ADDENDUM 5

DATE: 05/25/22

'Matilda Torres High School, Toros Stadium'
Matilda Torres High School
16645 Road 26. Madera, CA 93638

DARDEN PROJECT NO. 0622.4
DSA File Nos. 10-C3
DSA APPL. NO. 02-118396

Designed ByDesigner	Project Number: 0622.4
Drawn By: Author	Scale: 3" = 1'-0"
Checked ByChecker	Copyright 2020 Darden Architects
Reviewed ByApprover	AD5-AX04
Date: 05/28/2021

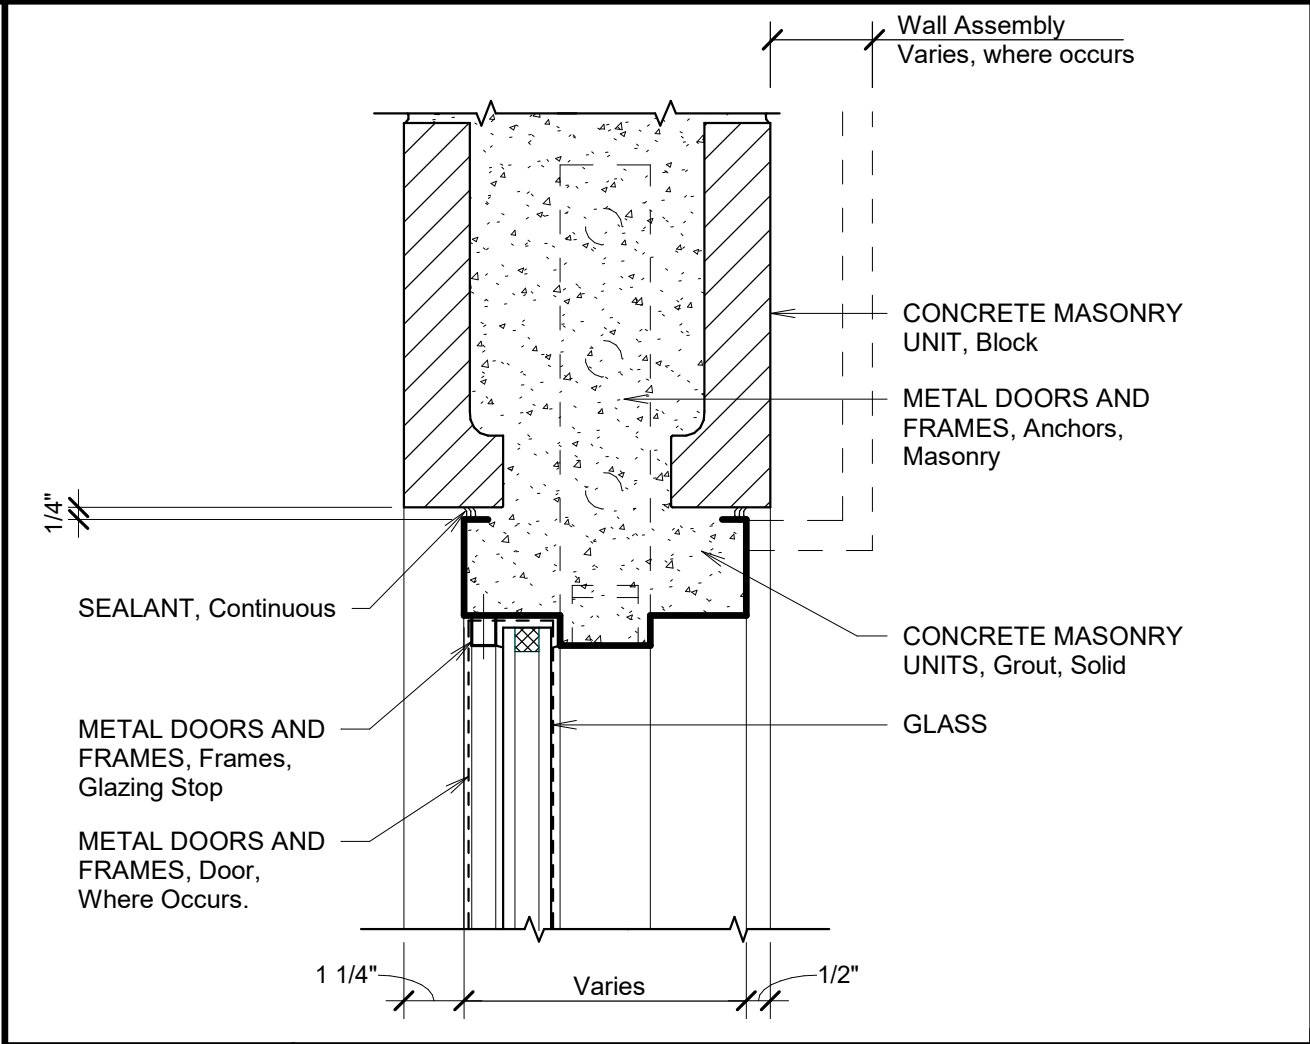
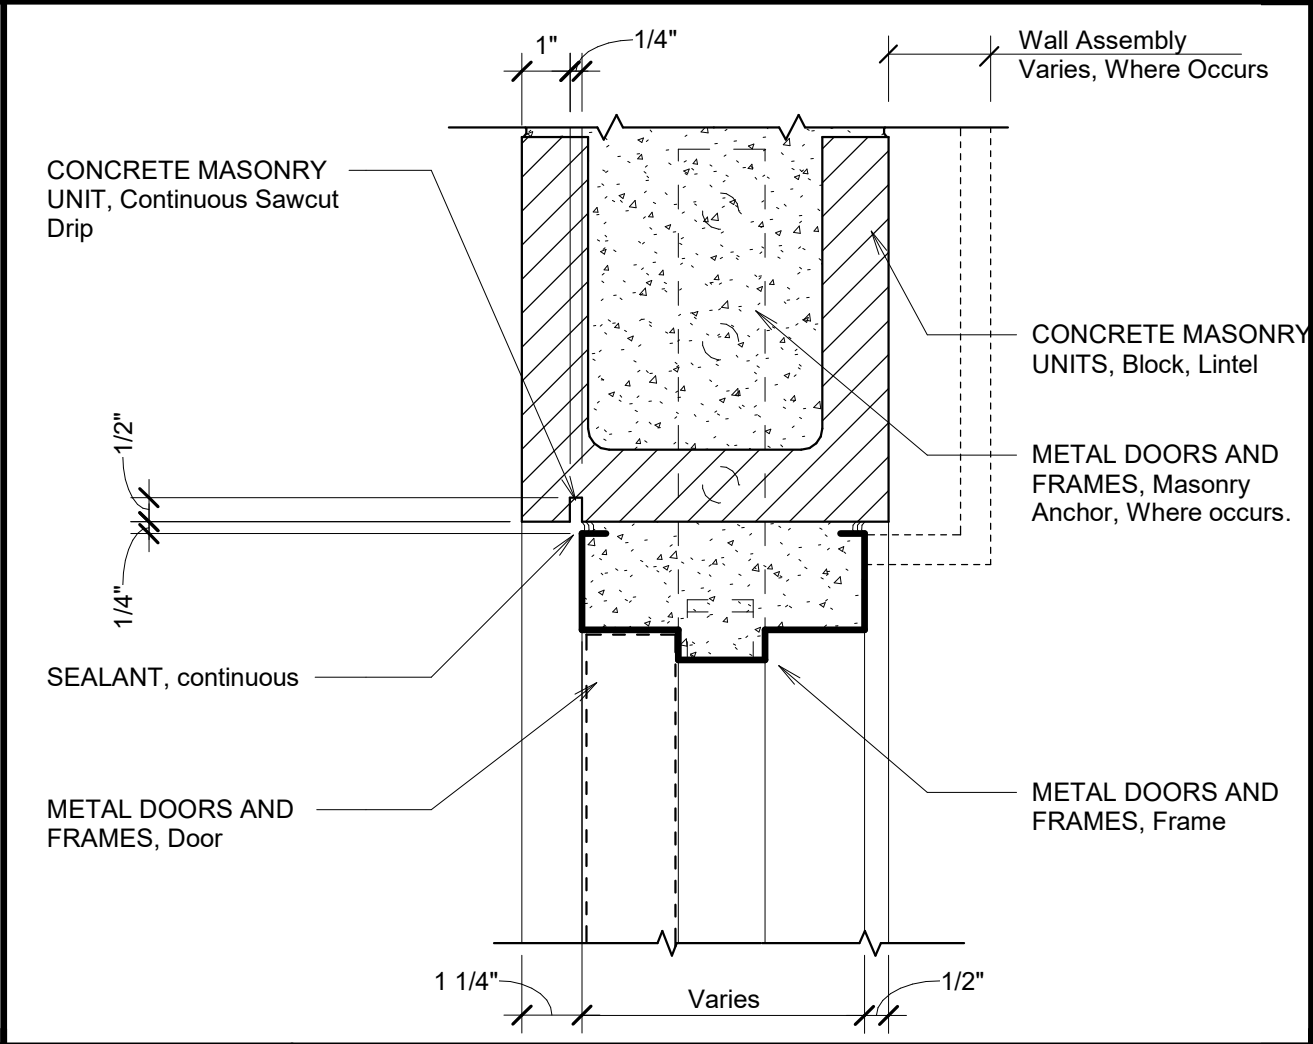
AD5-A04 Refer to Sheet X/A411 and X/A401

1. Add detail E14 in attached exhibit AD5-AX04 to sheet X/A411
2. Add detail
3. Revise door Schedule on sheet X/A401 for doors Q1110a and Door Q2124a as indicated in revised opening schedule on AD5-Ax04

E14	METAL DOORS AND FRAMES, Jamb and Sill at Exterior
3" = 1'-0"

E11	METAL DOORS AND FRAMES, Head at Exterior
3" = 1'-0"

Revised Doors in CMU wall
Add details at E11 - X/A411 and E11- X/A411

AD5-AX05

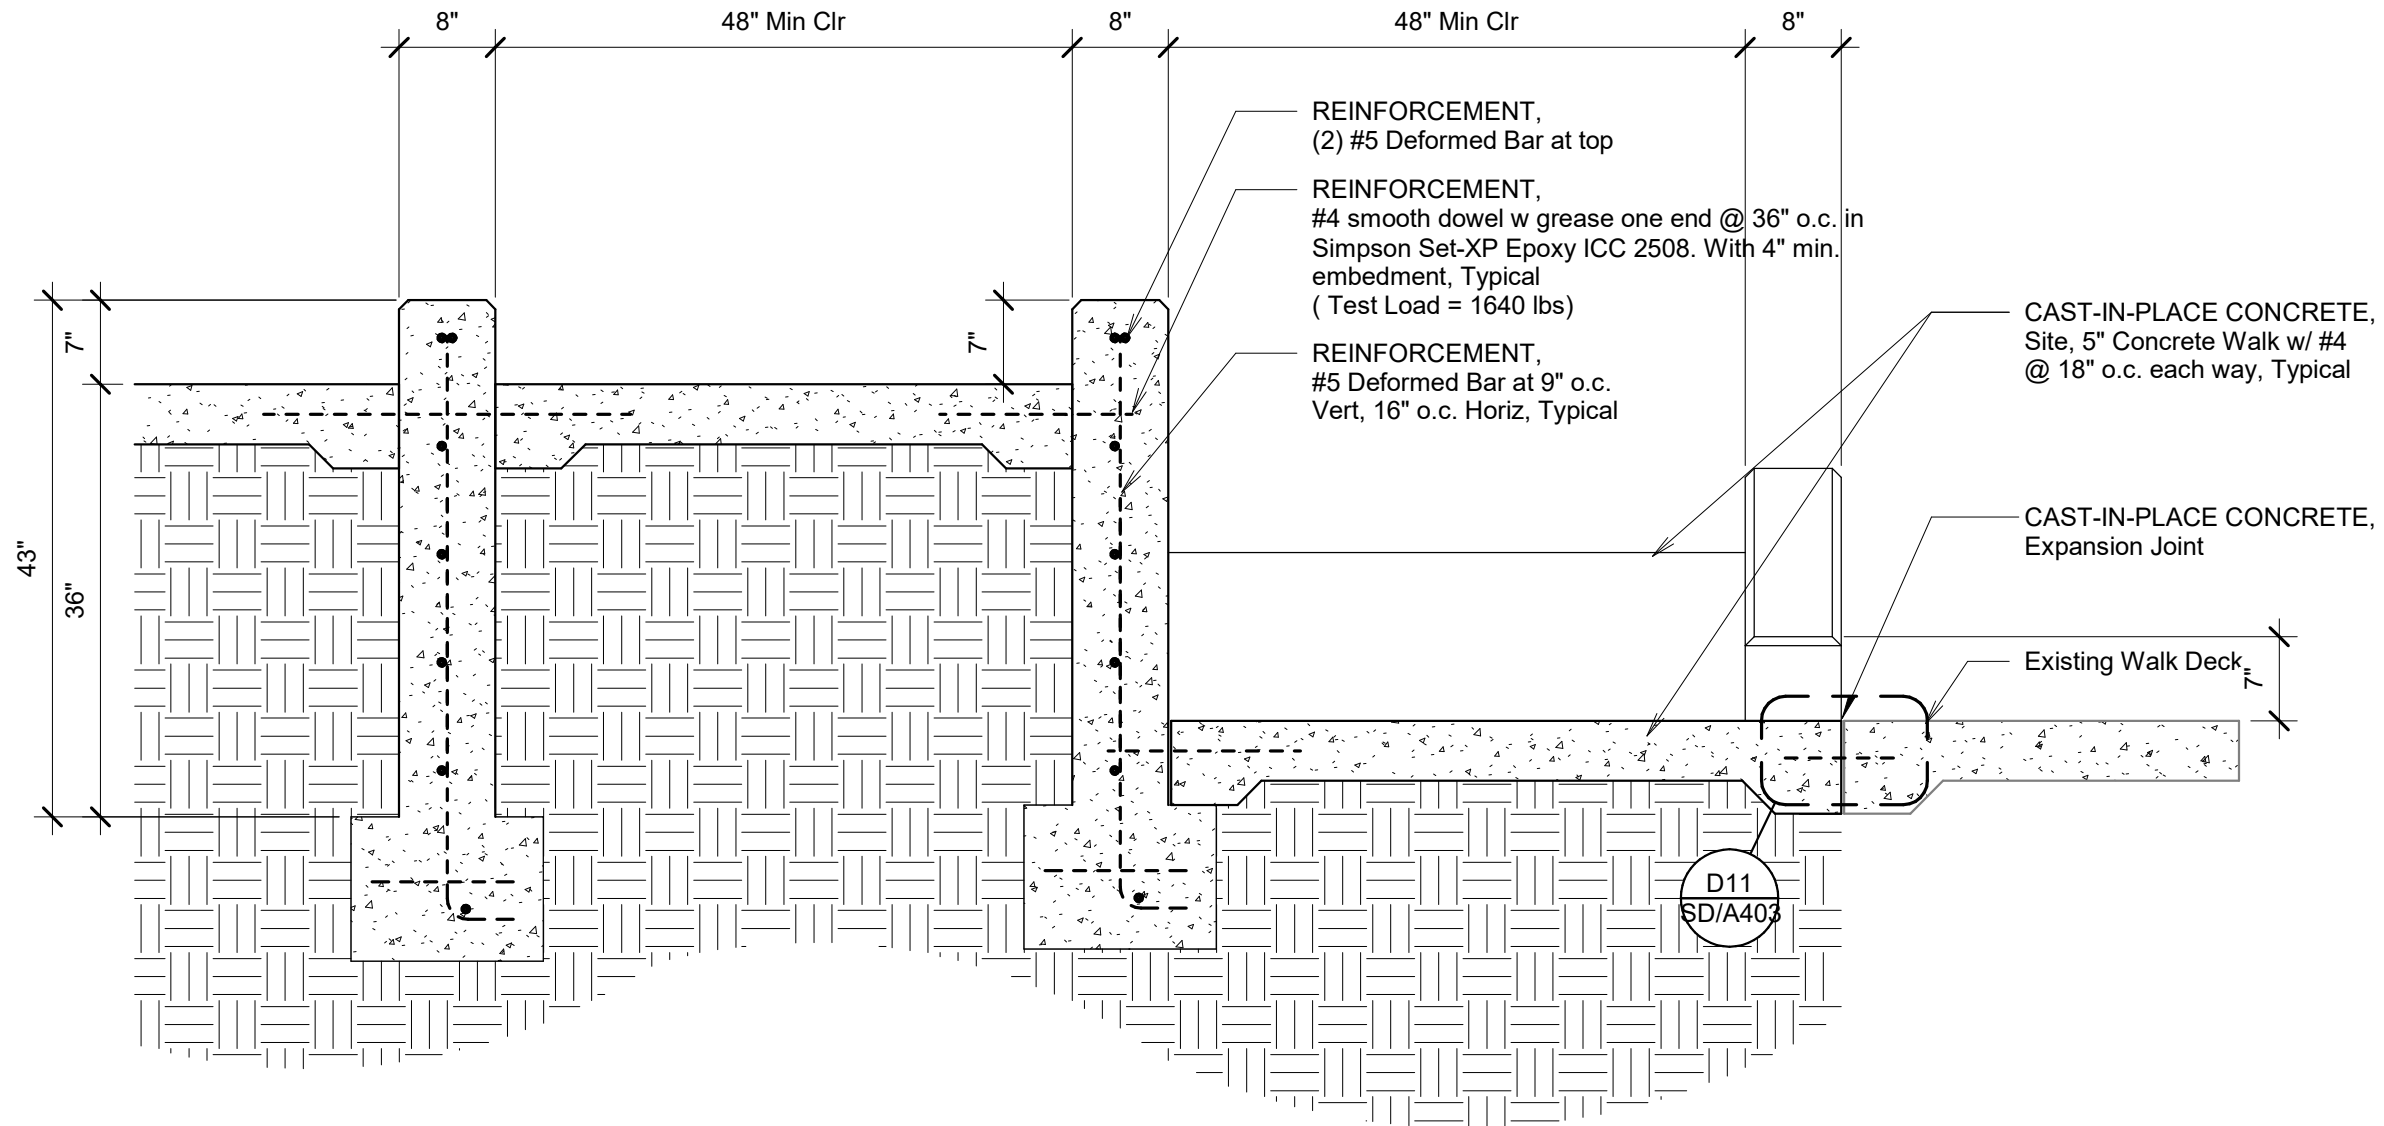
AD5-A05 Refer to Sheet SD/A404

1. Replace detail F4, Section A with attached exhibit AD5-AX05
2. Replace detail F4, Section B with attached exhibit AD5-AX06
3. Replace detail F4, Section A with attached exhibit AD5-AX07
 - a. At detail F4, remove references to 3" rock base. Install ramps and flat work over compacted earth as indicated in detail D11 - SD/A403
 - b. Provide thickened edge at walk transitions as shown in updated detail

SECTION A - SLOPED WALK / RAMP SECTION AT BOTTOM LANDING

Section A
Detail F4 SD/A404

Q/S201

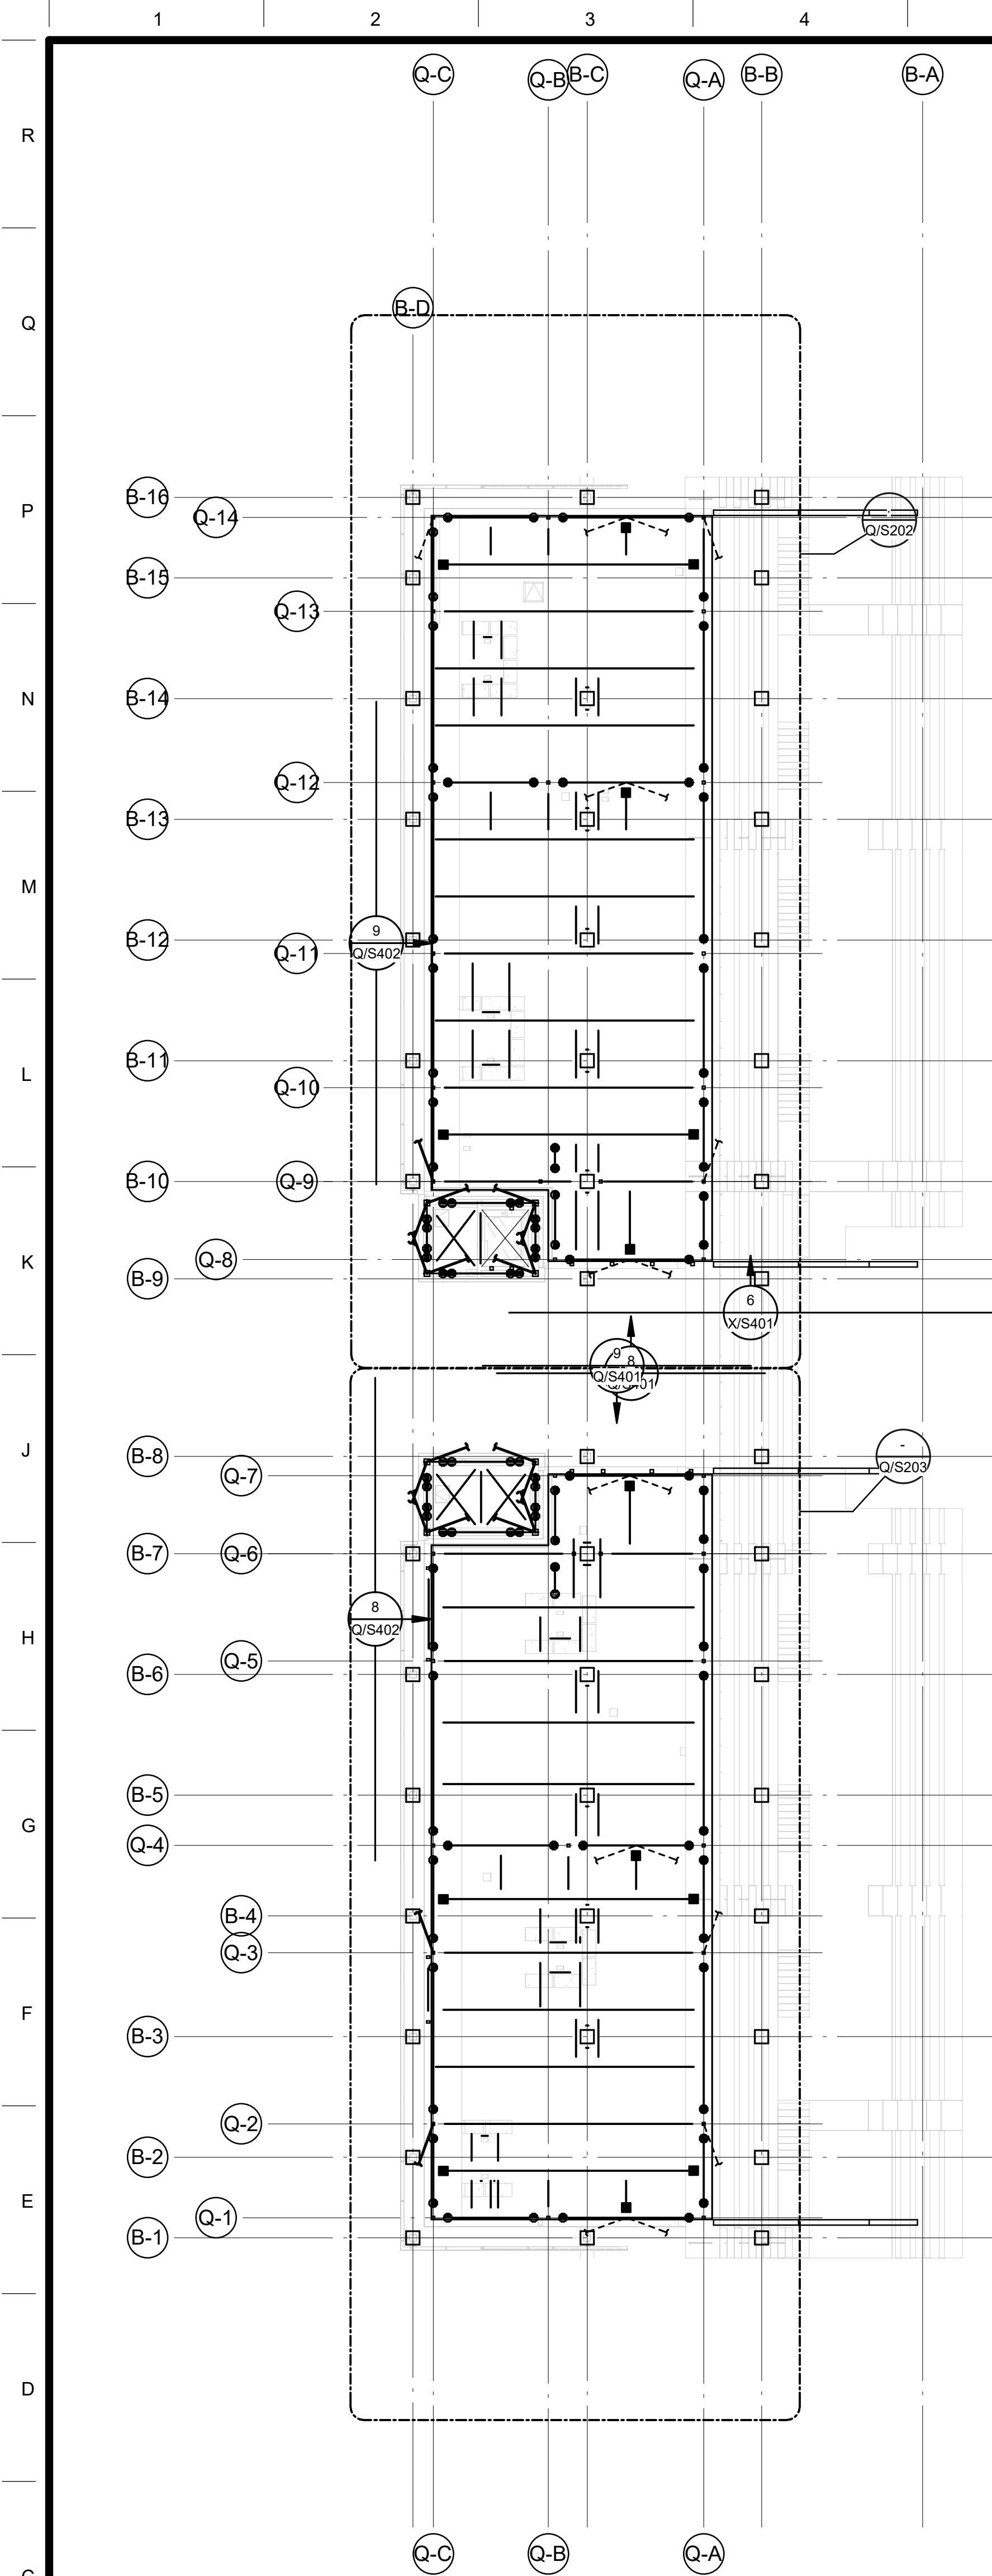
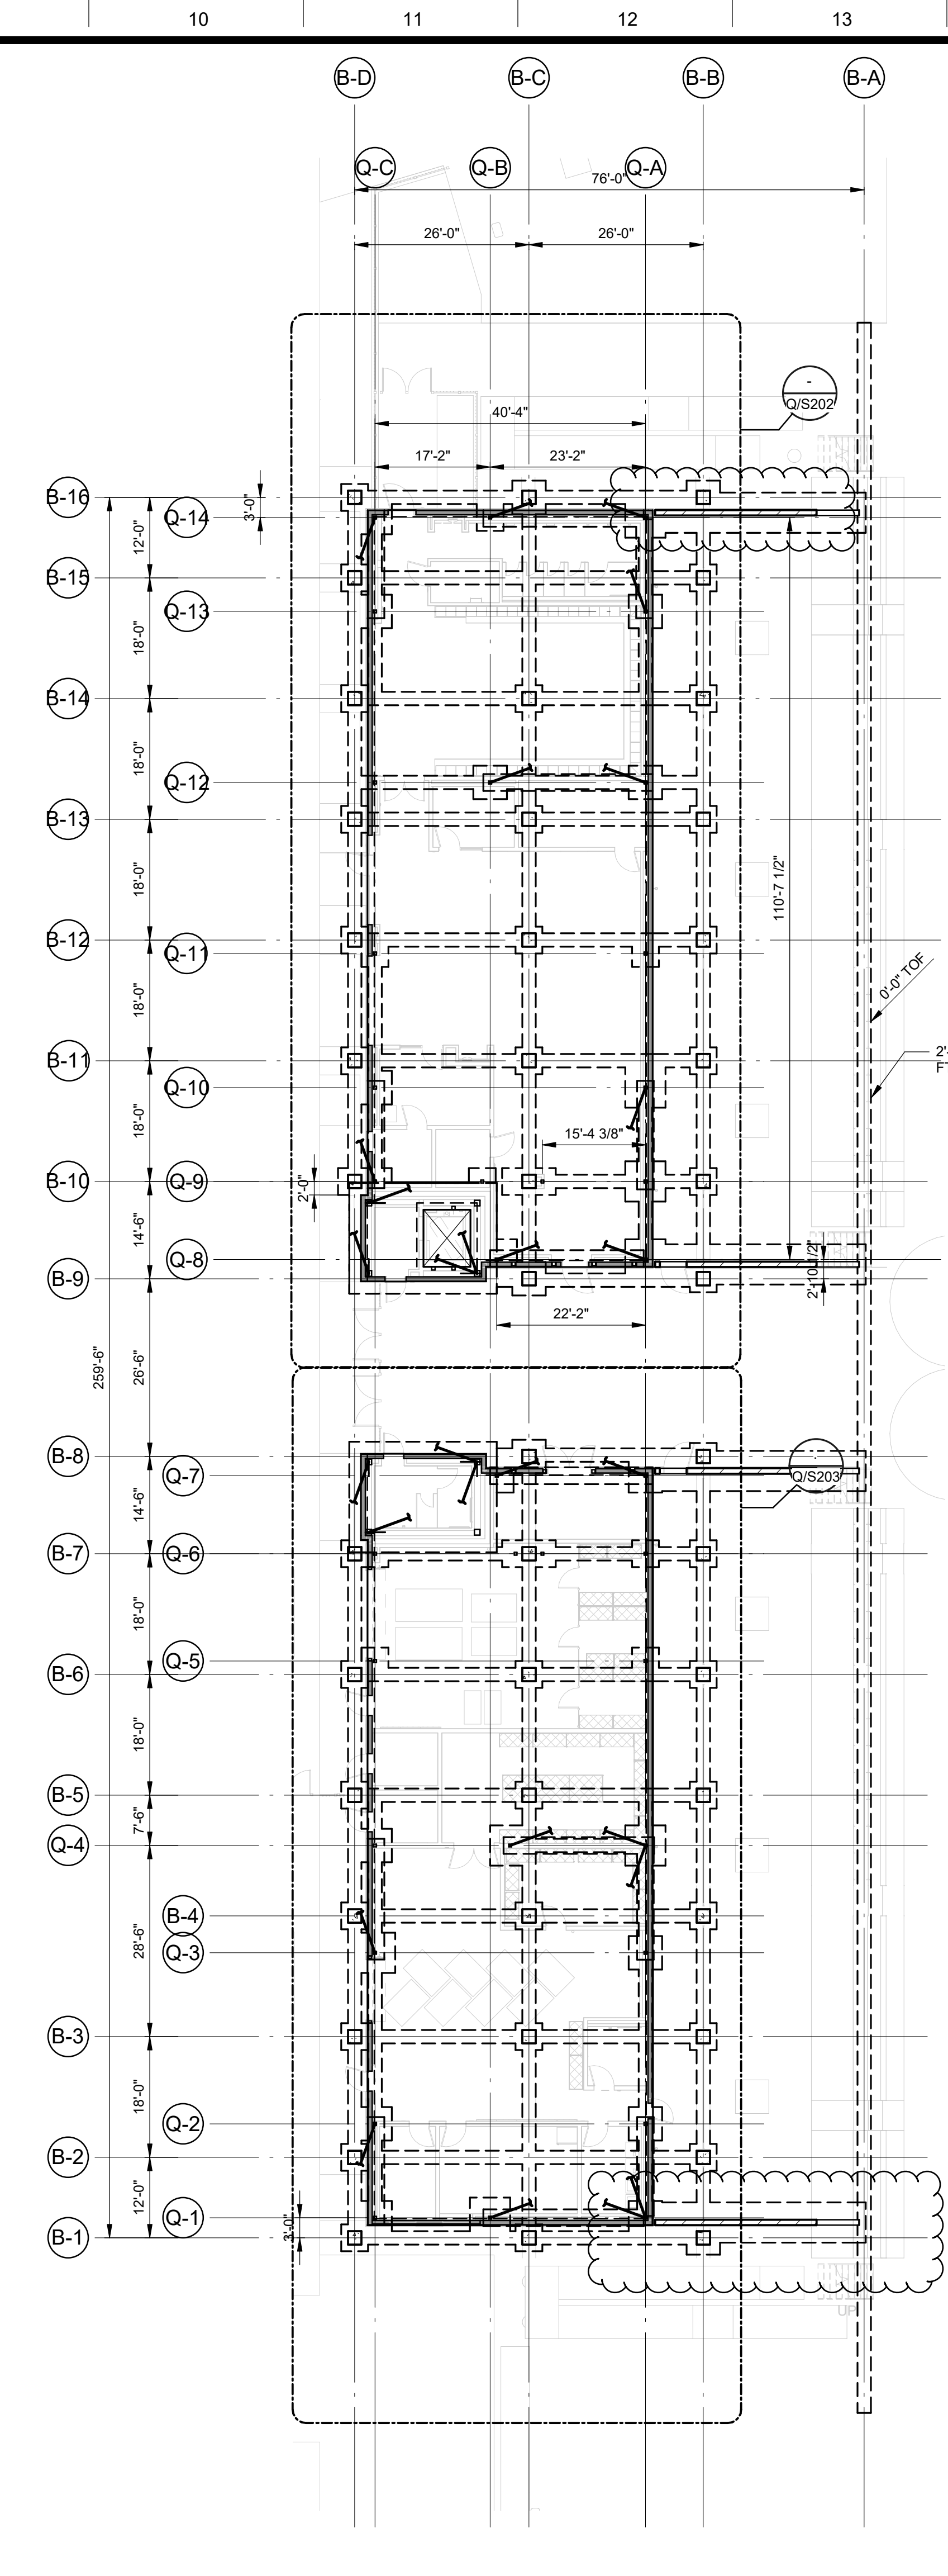
AD5-S01 Refer to Sheet Q/S201

1. Replace sheet with attached exhibit AD5-SX01
 - a. CMU wing walls and footings clarified.
